DATE: November 8, 2016

File: PDP 16-04

TO: PLANNING COMMISSION

RE: Urban Apartments Planned Development Permit
Located at 1033 W. 5th Street & 1046 W. 6th Street (APN 004-202-007 and -018)

TITLE: SITE PLAN
NOT FOR CONSTRUCTION

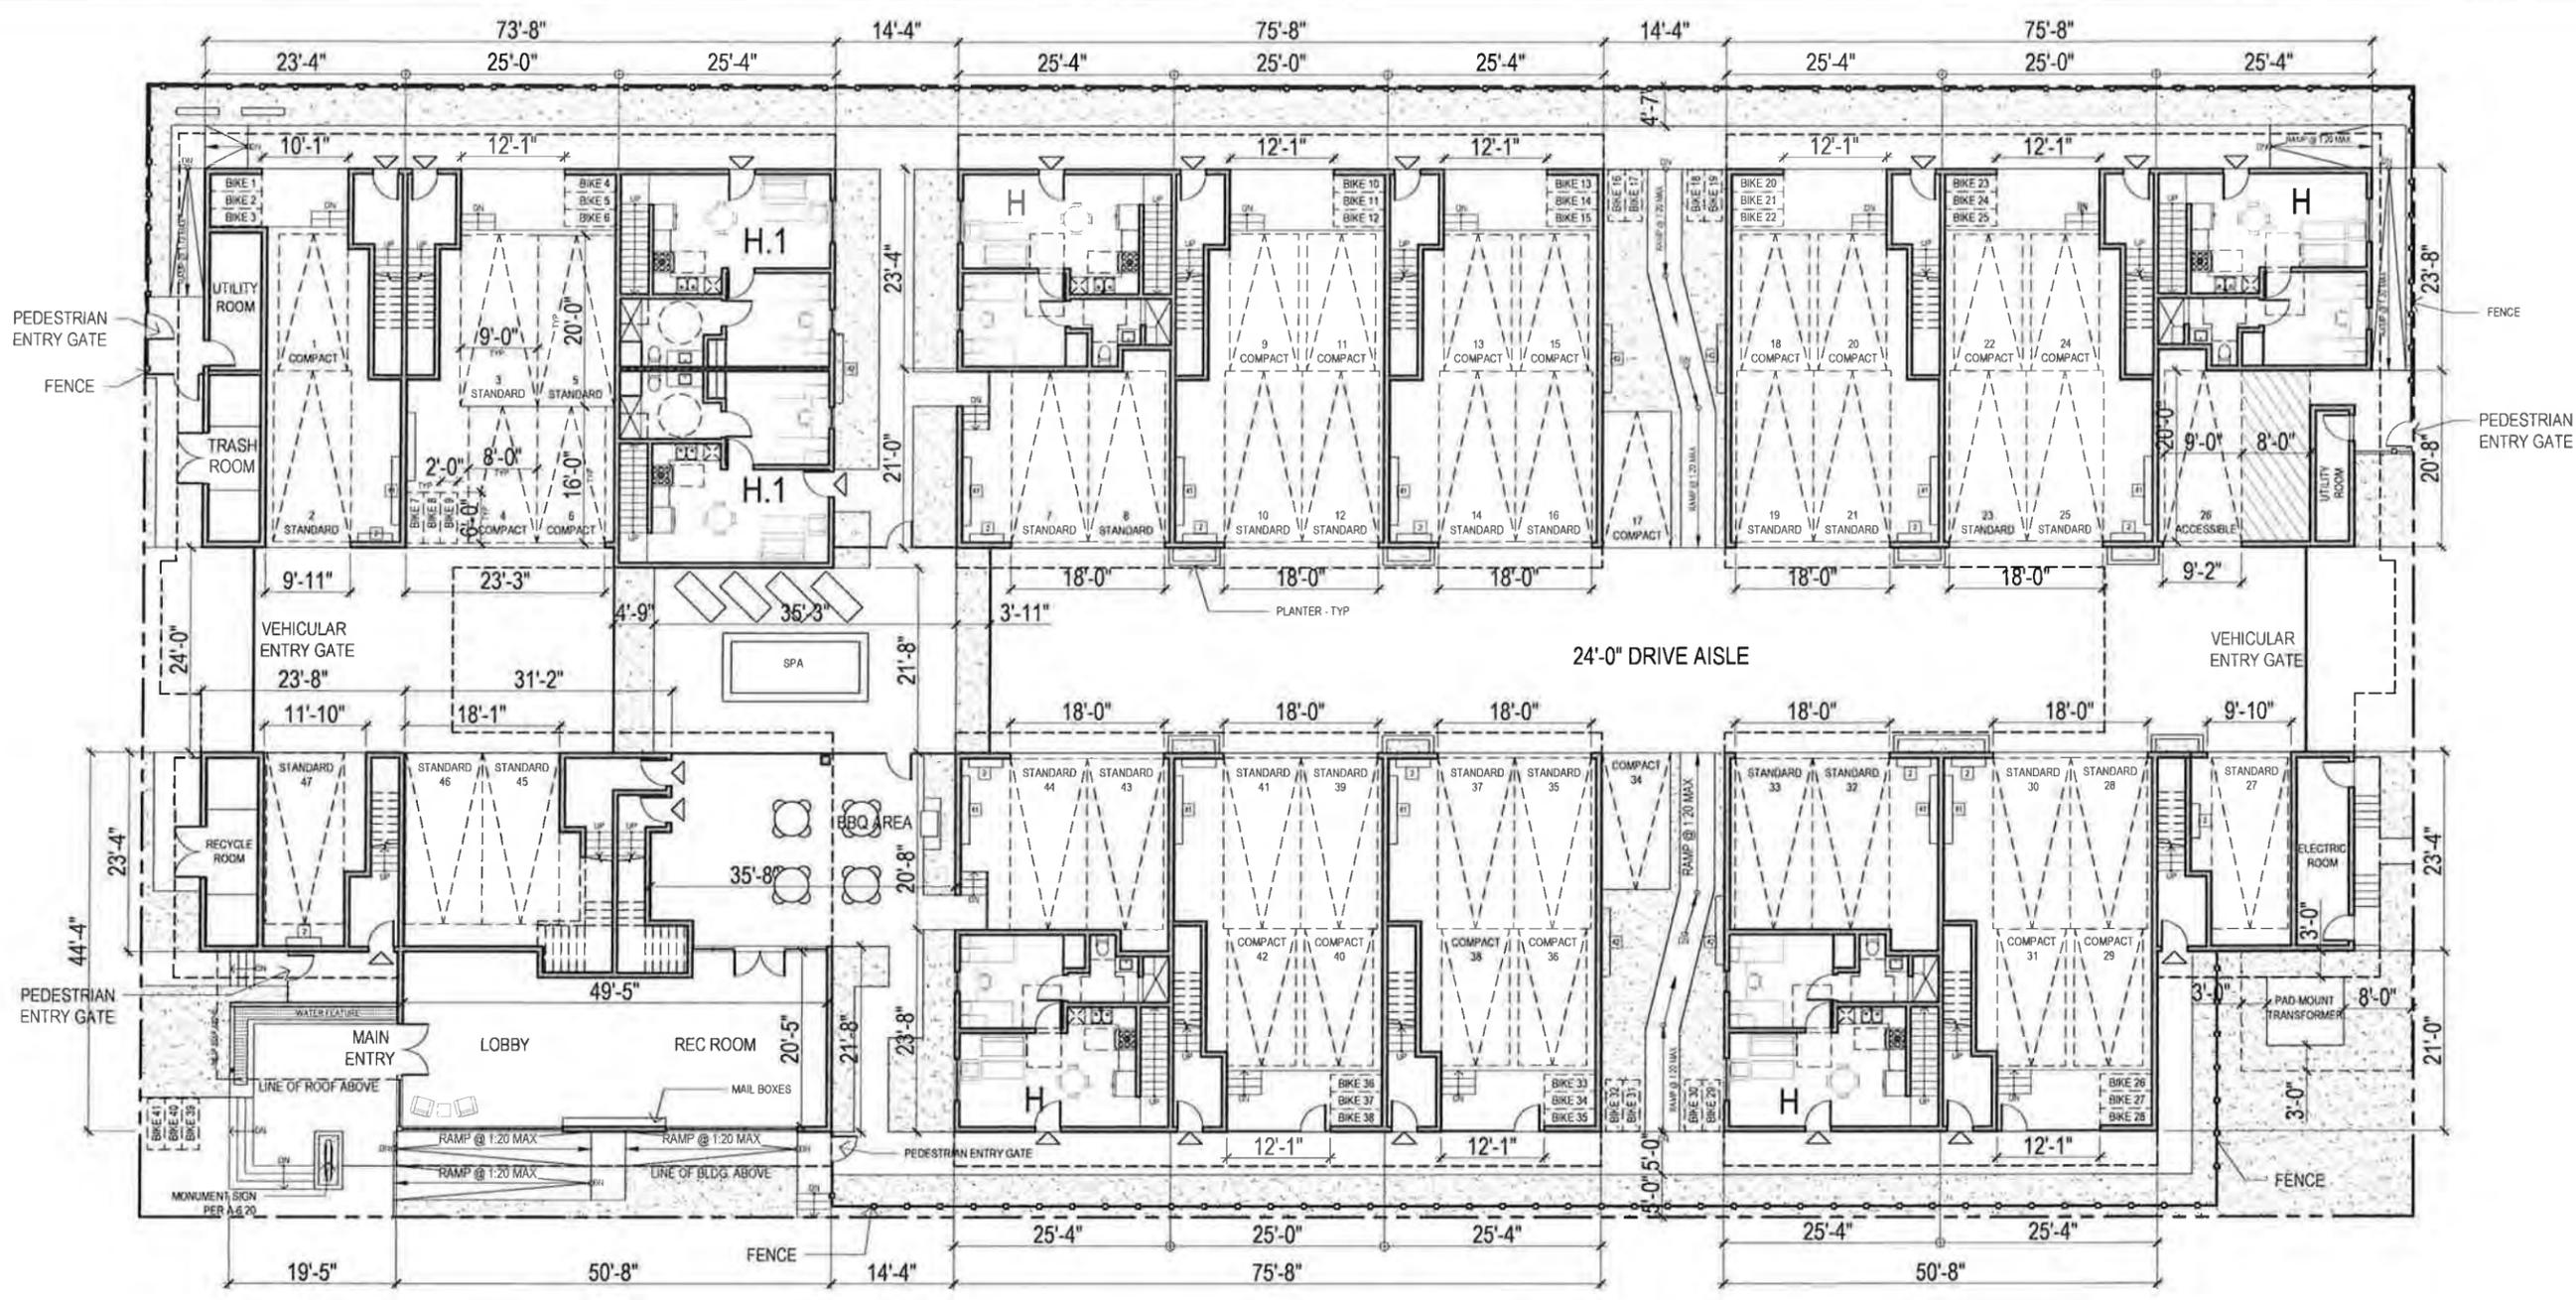
The project under review includes building structure above the driveway access off of both West 5th Street and West 6th Street. The project design does not provide the minimum vertical clearance of 13 feet 6 inches for fire access lanes. Therefore, the fire department access roads to the structure located along the back side of the property (identified as Building 4) are limited to the public roads adjacent to the project as no on site fire lane is possible. The fire code requires all portions of the ground floor exterior walls to be within 150 feet of fire apparatus access (Reference CFC 503.1.1 2007 ed). The materials submitted for review show routes of travel from fire apparatus access roads to all portions of Building 4.

As noted above fire apparatus access to one building in the project is impaired but materials submitted for review show firefighter access from the fire apparatus access point to be within the 150 feet. The longest measurement shown on the plan provided is 148 feet. However, measurements shown are taken from the face of the curb and do not account for parked vehicles. The actual distance will likely be greater than the code minimum. The code allows the distance to be increased for buildings equipped with an automatic fire sprinkler system. The project designer has indicated the project will utilize the NFPA 13 (life safety & property protection) design standard for the project rather than the NFPA 13R (life safety only) design.

1. Since the proposed plan does not allow Building 4 to be accessed by the fire department's ladder truck the final plan shall designate ladder access points subject to approval by the fire department. Ladder access points shall not exceed 32 feet above grade at building 4. Ladder access points shall provide access to all portions of the roof above living spaces, equipment and building services mounted on the roof, and a clear route of travel to roof top decks. Grading and landscape plans shall identify ladder access points and shall be kept free of landscape plants or other obstructions.

Based on the materials provided, the path of firefighter travel from the fire apparatus to Building 4 is approved. The final site plan shall indicate a clear path of travel not less than 36 inches wide, unobstructed by landscape or other features. If necessary, the plan shall provide additional access gates, subject to approval by the fire department, for access to all buildings.

ROOF PLAN
3/32" = 1'-0" 2

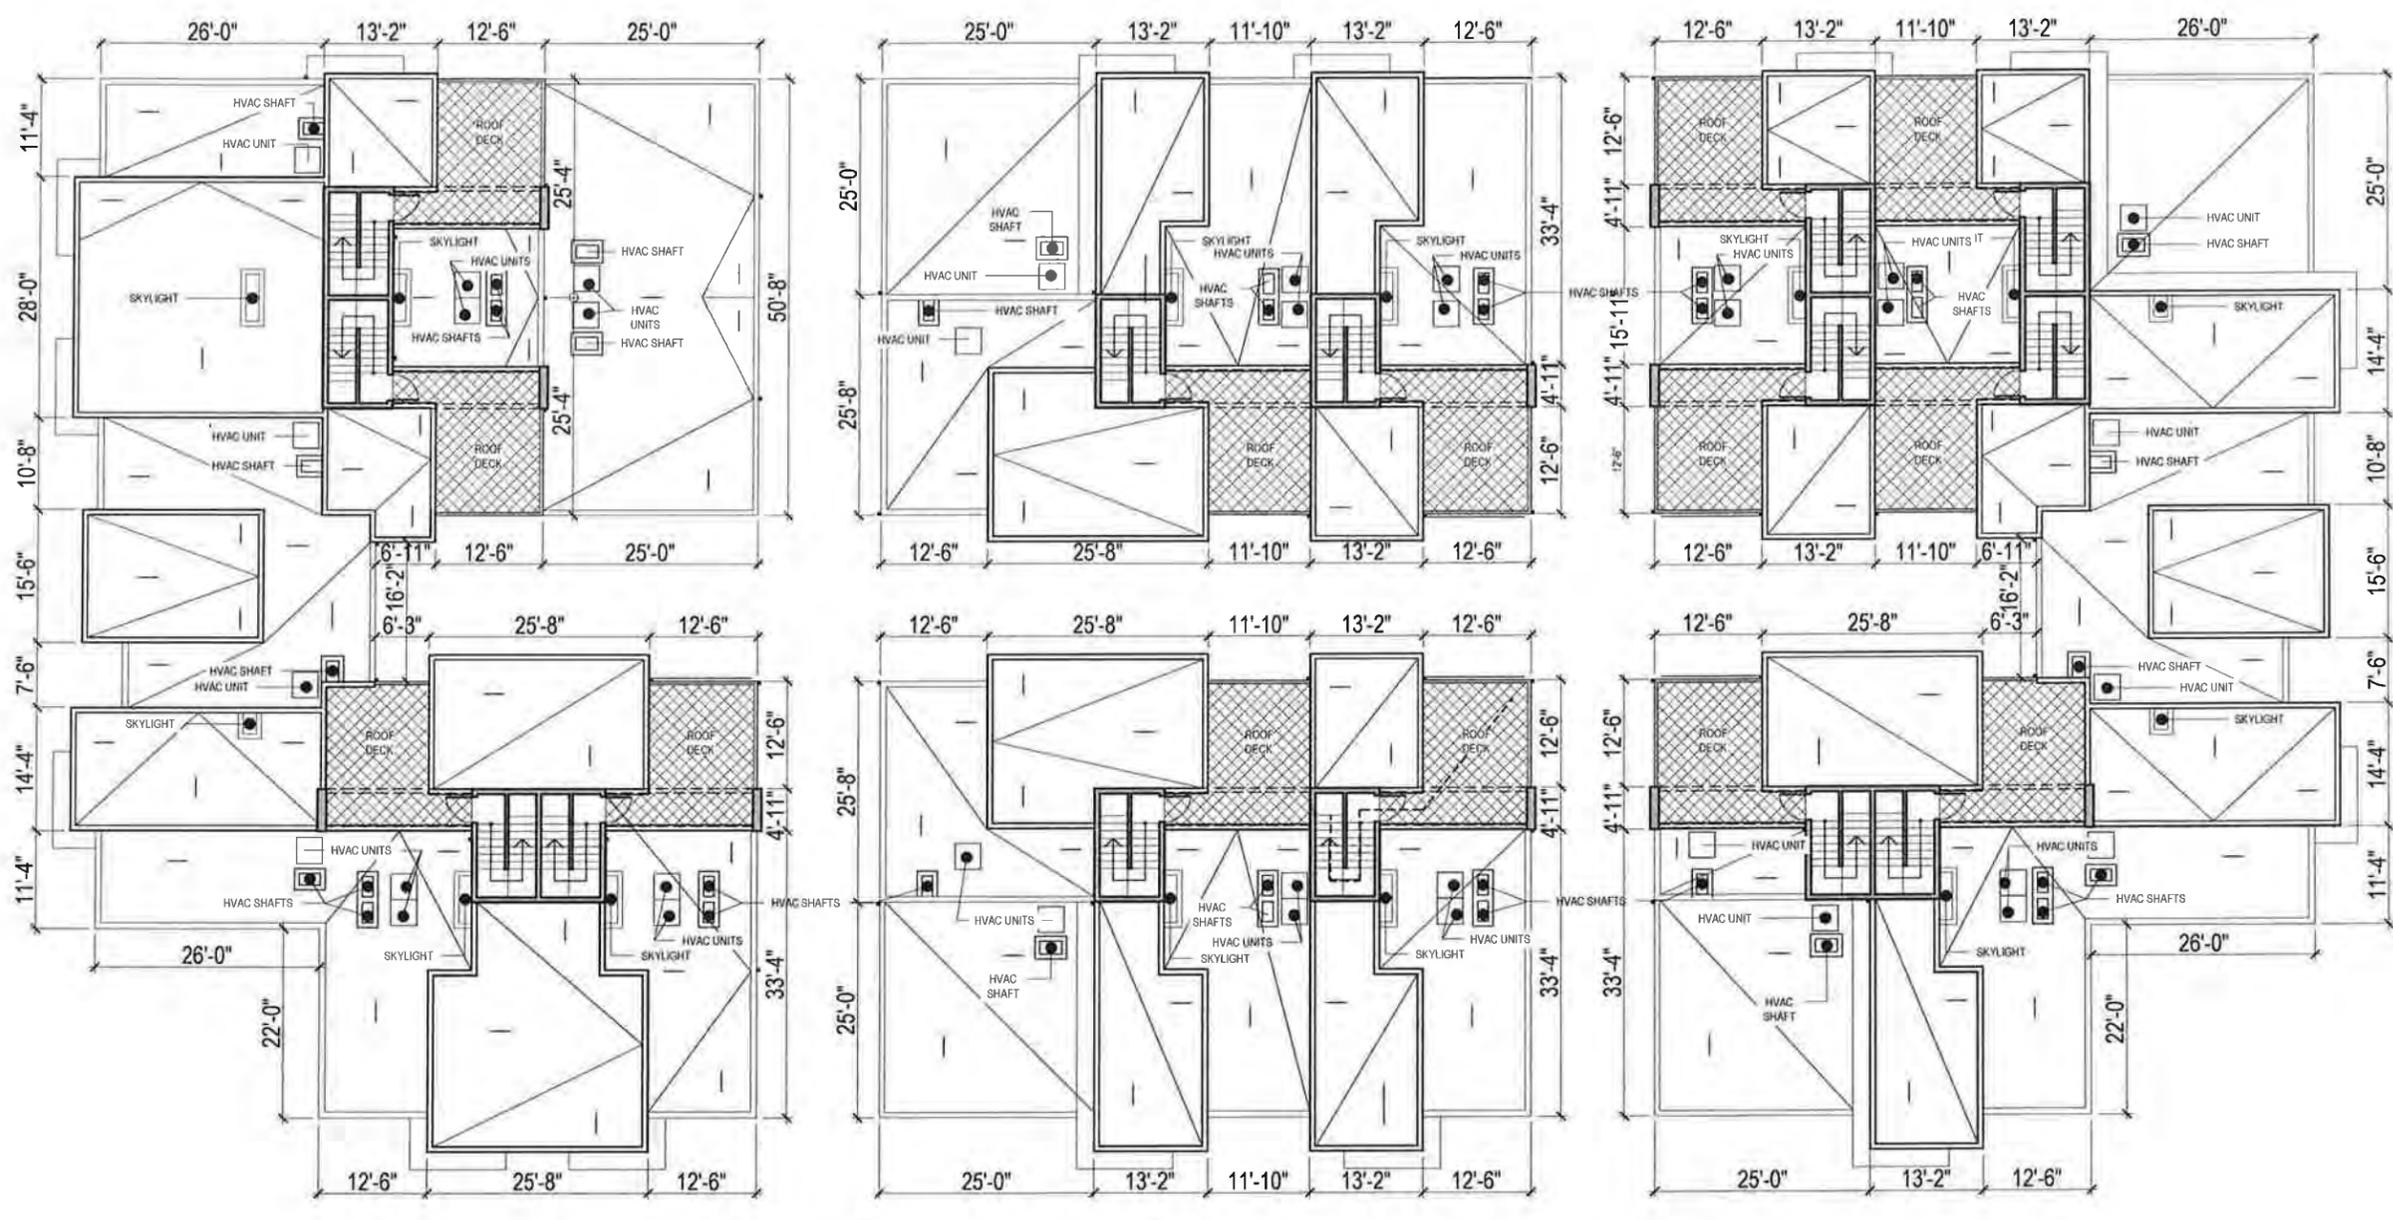
1. Roof top decking materials shall be non-combustible or limited combustible materials that comply with the requirements of CBC 709A.3. The final plan submitted for building permits shall demonstrate compliance with this condition.
2. Administrative controls shall be incorporated in the lease agreements to reduce the fire hazard on the roof top decks. The lease agreements shall explicitly prohibit the use of upholstered furniture on the roof top decks. Furnishing shall be limited to non-combustible or limited combustible furnishings intended for outdoor use only. The lease agreements shall also prohibit the use of cooking appliances or other fuel fired appliances (outdoor fireplace, heaters, decorative flame devices, etc.) from being used on the roof top decks.

SHADE STUDY MODEL IMAGES

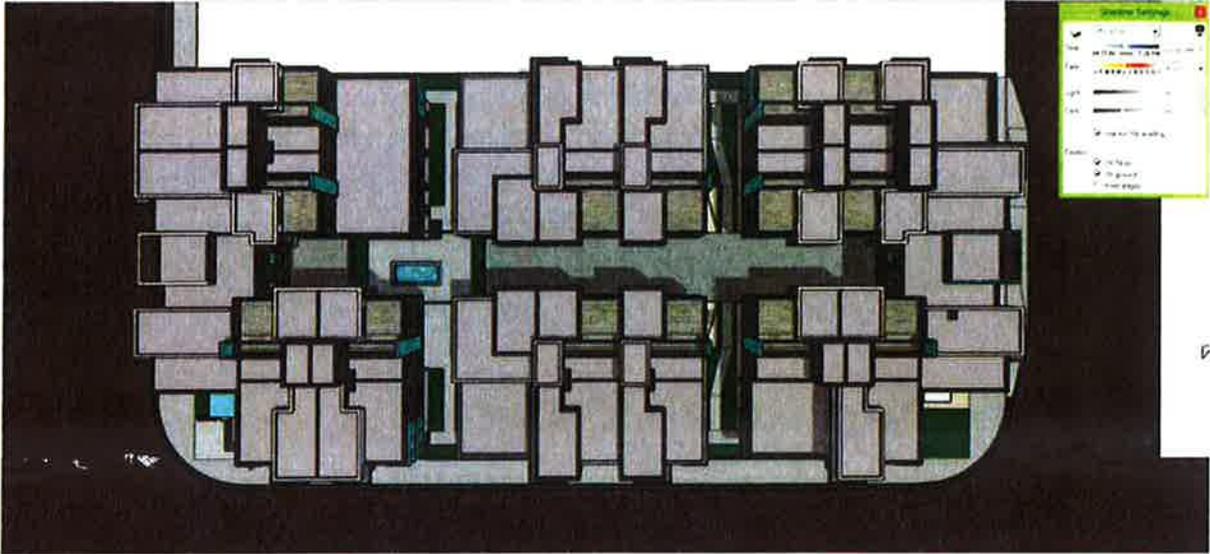
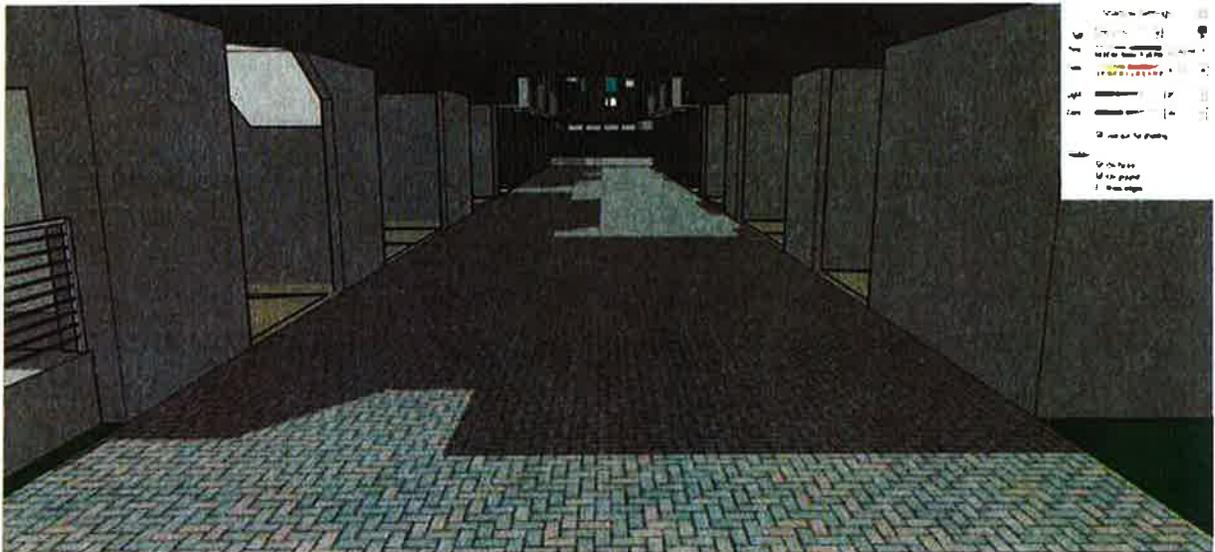
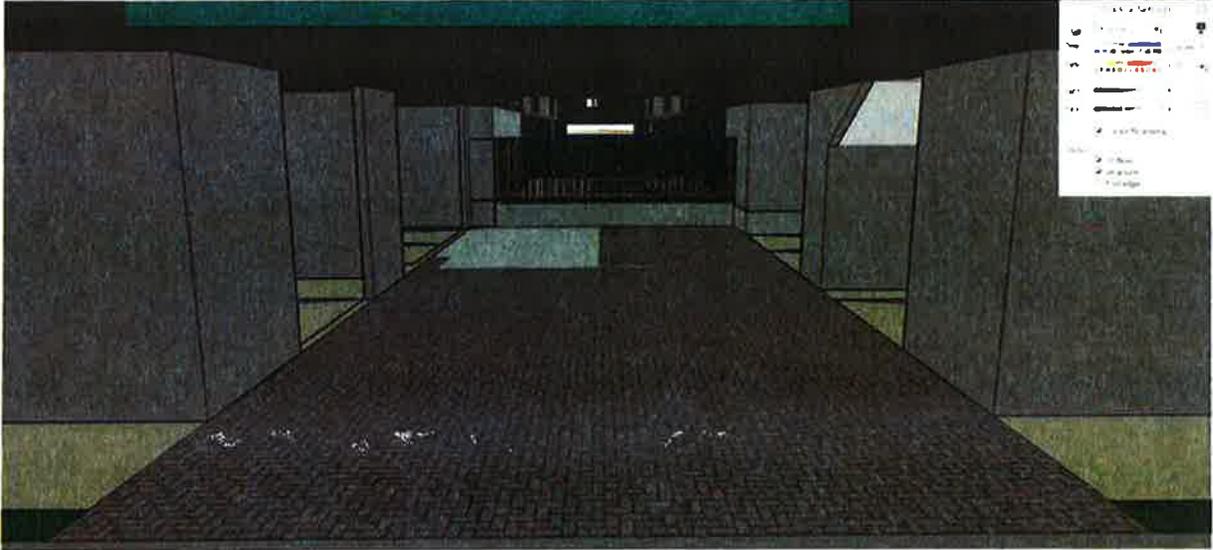
Should staff not agree with the interpretation in the preceding paragraph then a second solution would be to analyze the shading of the entrance drive aisles at noon on June 21st as the code indicates. As proposed the entrance drive aisles constitute a total area of 5,313 SF with 2,193 SF (41%) of that directly covered by the building. However, this figure does not account for shadows cast by the building which puts a further amount of the entrance drive aisles in shade. Based on solar shade studies done using 3D Modeling software that incorporates solar paths throughout the day/year (see attached Model Images), at noon on June 21st 3,333 SF of the entrance drive aisles are in shade. This results in 63% of the entrance drive aisles being in shade on June 21st at 12:00 noon.

We feel strongly that the intent of the code is being met in that well over 50% of the paved areas provided for parking are in shade at the designated time of day/year. As such we are requesting that planning staff support our PDP request to allow the required shading to be provided by the building in lieu of the required trees.
